STAFF RECOMMENDATION
1713 Sweetbriar Avenue
September 19, 2012

Application: New construction-rear addition and alterations
District: Belmont-Hillsboro Neighborhood Conservation Zoning Overlay
Council District: 18
Map and Parcel Number: 11704007300
Applicant: Stone Oak Builders, Josh Belville
Project Lead: Robin Zeigler, robin.zeigler@nashville.gov

<p>Description of Project: The applicant proposes a rear addition on a contributing building in the Belmont-Hillsboro Neighborhood Conservation Zoning Overlay.</p> <p>Recommendation Summary: Staff recommends approval with the conditions that:</p> <ul style="list-style-type: none"> • Staff review trim, deck, windows, doors, garage doors, and roof color prior to purchase and installation; and • Utility locations be reviewed by staff if new locations are planned. <p>With these conditions (that the applicant has agreed to), the project meets II.B of the design guidelines for new construction and additions.</p>	<p>Attachments A: Photographs B: Site Plan D: Elevations</p>
---	--

SITE PLAN

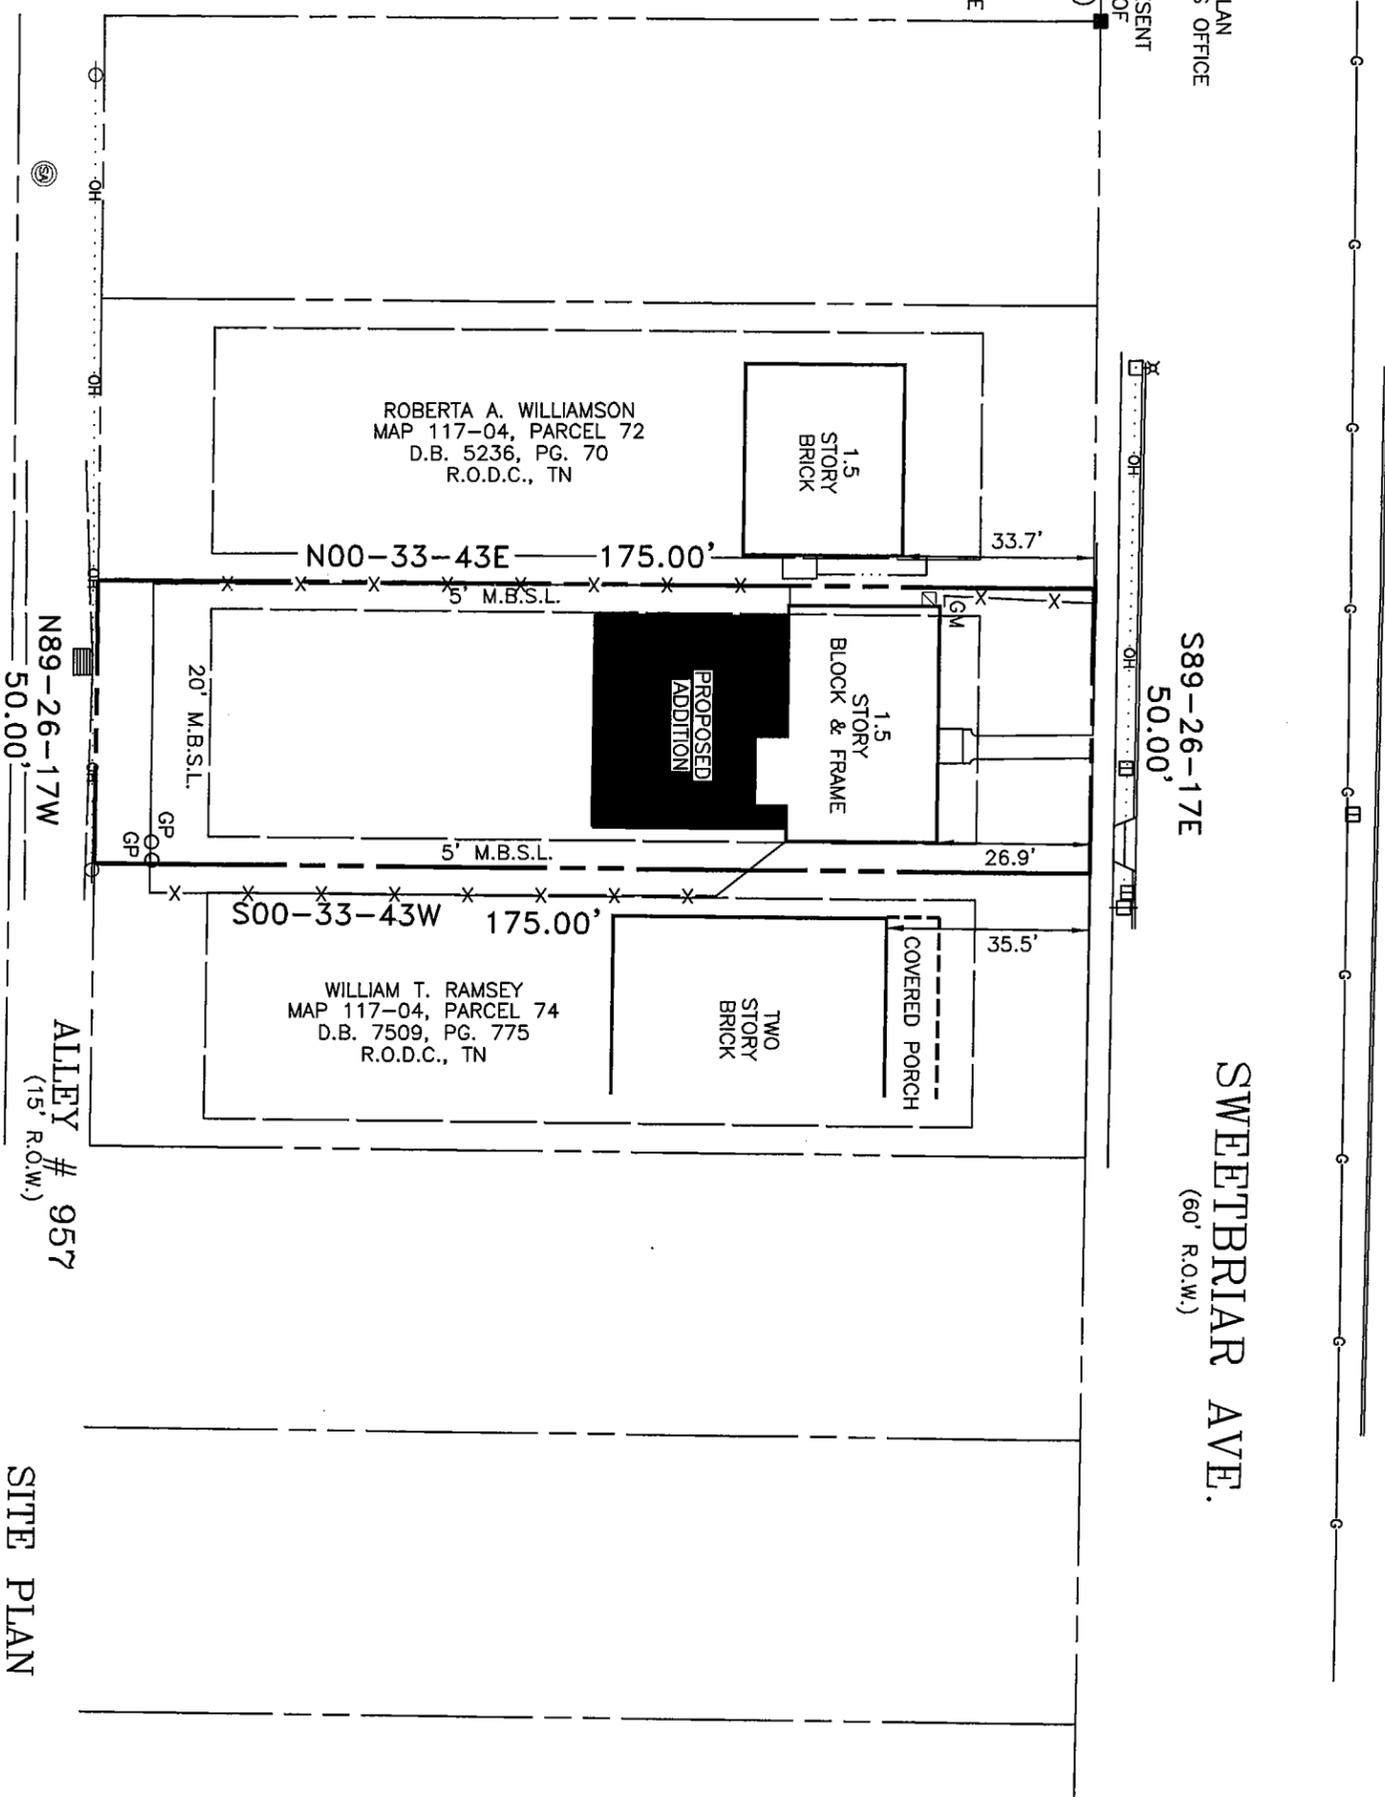
Setback and Rhythm of Spacing: The addition sits within all of the required setbacks of bulk zoning and does not alter any existing setbacks. The project meets section II.B.c. of the design guidelines.

FRONT ELEVATION

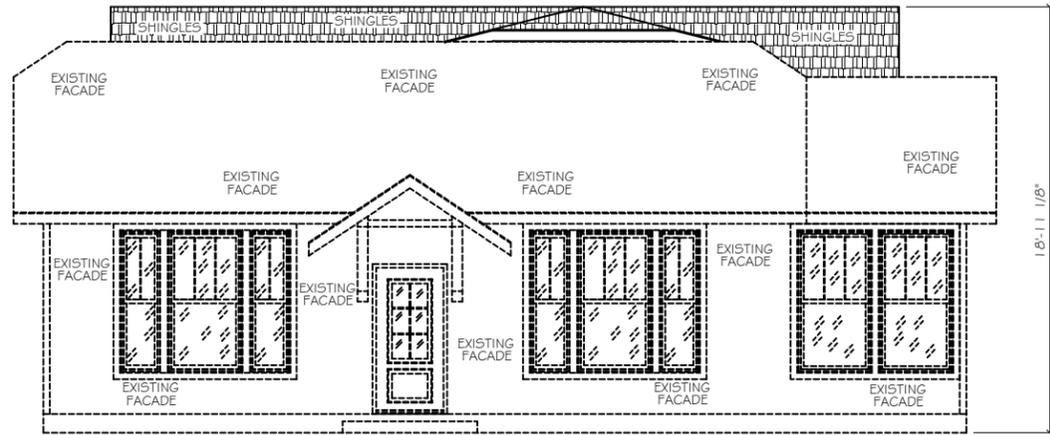
The addition will rise above the existing house by two feet (2'), approximately twenty-six feet (26') from the front wall of the house. Previous additions to one-story homes have been allowed up to four feet (4') taller as long as the additional height did not happen until forty-feet (40') beyond the front wall of the house. Since this addition will only rise two feet (2') staff found that twenty-six feet (26') beyond the front wall of the house to be appropriate.

Wall dormers are discouraged as they are not typical for the historic overlay; however, this one is small in scale and located towards the rear of the house with minimal visibility.

Proportion and Rhythm of Openings: The addition does not have a blank wall of more than fourteen feet (14'), which matches the historic context in terms of rhythm of openings. The proportions of most of the new windows are similar to the existing. Double windows have a dividing muntin of similar width to the existing. The windows of the right side/front addition (or enclosed side porch) are not original and will be replaced with windows of the same design as the existing. The new windows meet Section II.B.g of the design guidelines.

- Staff review trim, deck, windows, doors, garage doors, and roof color prior to purchase and installation; and
- Utility locations be reviewed by staff if new locations are planned.
